# Access Compliance Report

## Public Rights-of-Way

### (Curb Ramps)

Intersection ID: 46147	Main Street: ROCKY_FORD_CLUB_RD	Cross Street: ARBOR_CREEK_DR	Location: SW
ADA ID: 2EF96067F8D0	Ramp Type: PerpDiag	Initial Pass/Fail: Fail	Overall Compliance: No
Severity Score: 13.75			
Codes/Mitigation Info/Possible Solution		Field Measurements/Component Compliance

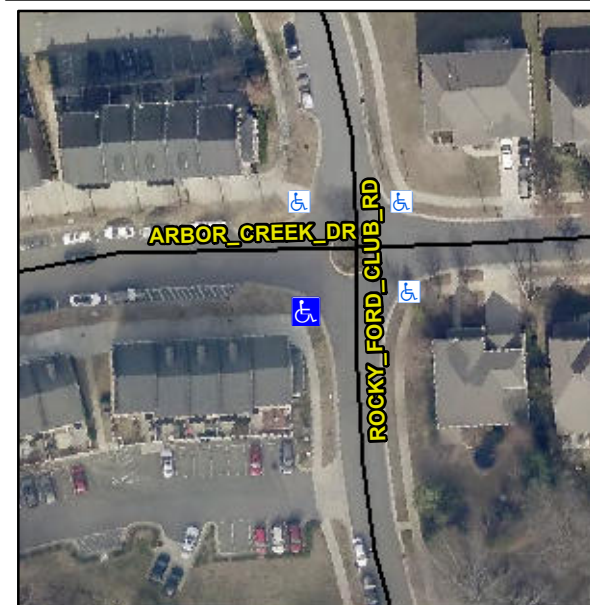
**Remove & Replace Curb Ramp With Two New Directional Ramps or Equivalent.**

**R304.2.2, R304.5.3**
